## Change Order #2 Las Milpas Road

Project: Las Milpas Road  
Contract: C-22-0094-09-06(ARPA 22- 122-109)  
Limits: McColl Rd (FM 3062) to 10<sup>th</sup> Street (FM 336)

**CONSTRUCTION CONTRACT CHANGE ORDER NUMBER: 2**

CO #2 - 12WL in conflict w/  
15" SS and Inlet A-1

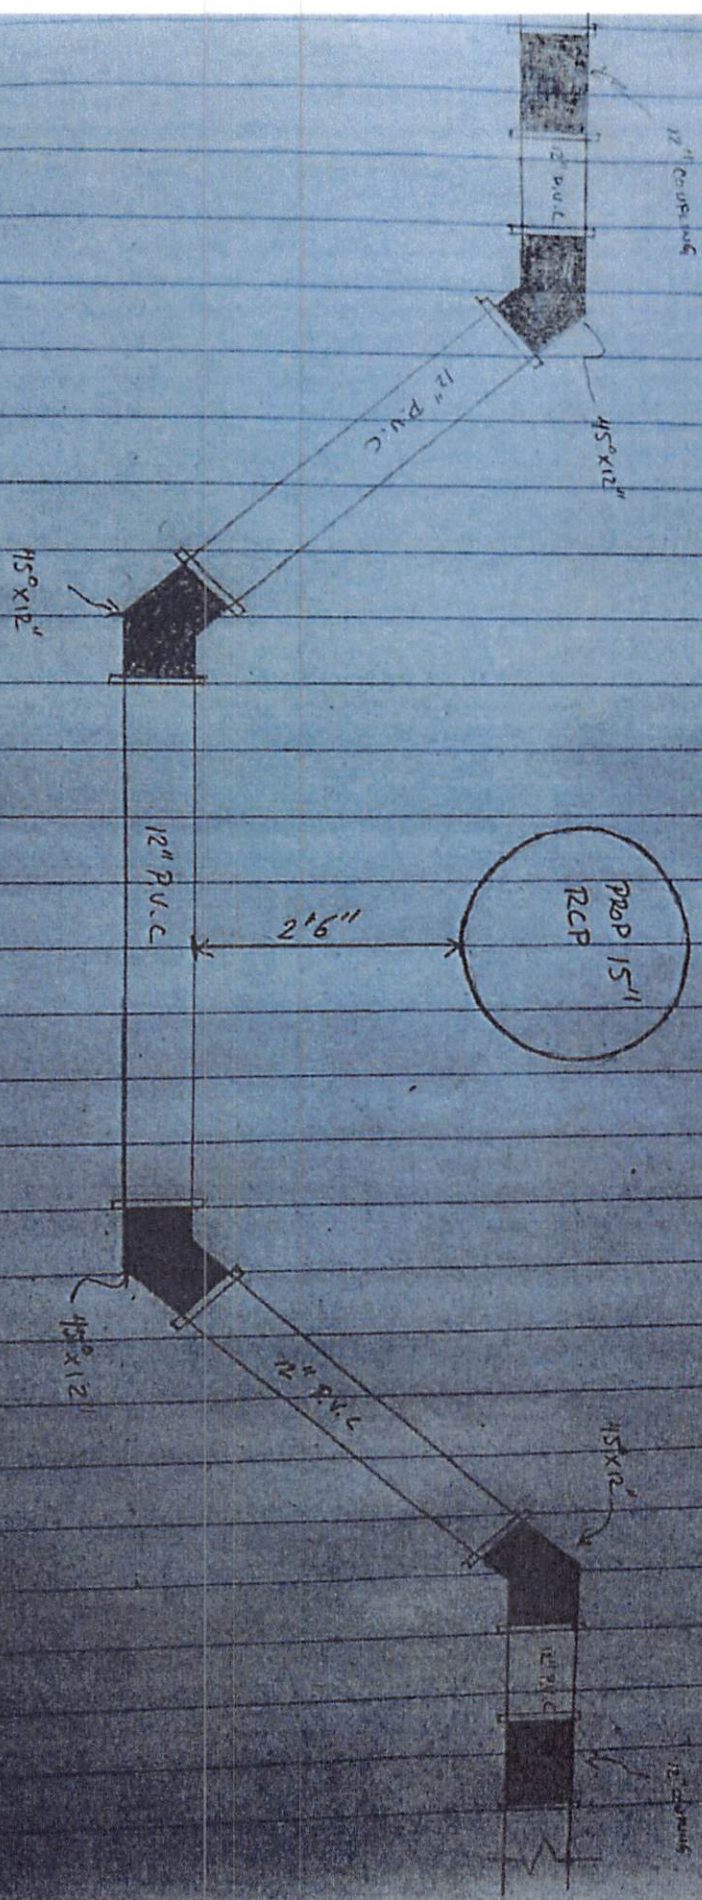
No time is added by CO #2. The revised plan sheet 115a shows the 12" waterline adjustment. Plan sheets 133a and 133b introduce two new standard plan sheets to cast in place the 7x7 and 7x9 box culverts in lieu of precast box culverts. GO will cast in place both structures at no extra cost to Precinct #2.

CO #2 - Change Order #2, relocate a 12" WL that is in conflict with the 15"SS & Inlet A-1 at McColl Rd. The City of Hidalgo 12" WL to go under Inlet A-1 and the 15" RCP and reconnect at McColl Rd.

133a
SCC-7

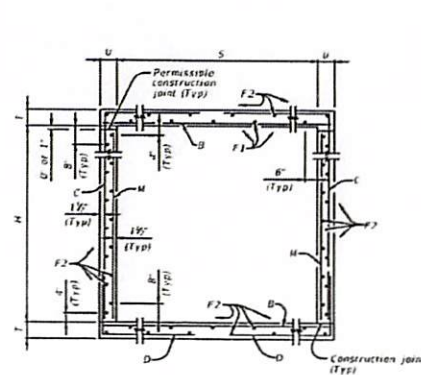
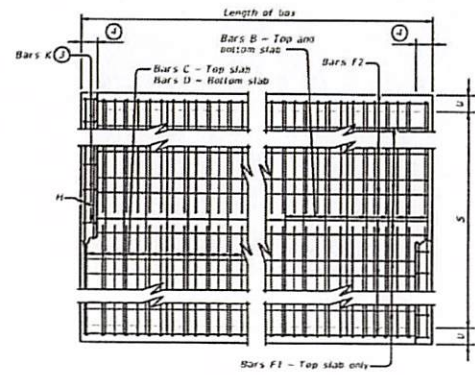
Added plan sheets - 133a,133b, Cast In Place(SSC-7, 7' Single Box Culvert, 0'-30' Fill)

**CO #2 - Add plan sheet to provide a Cast in Place Standard Sits**
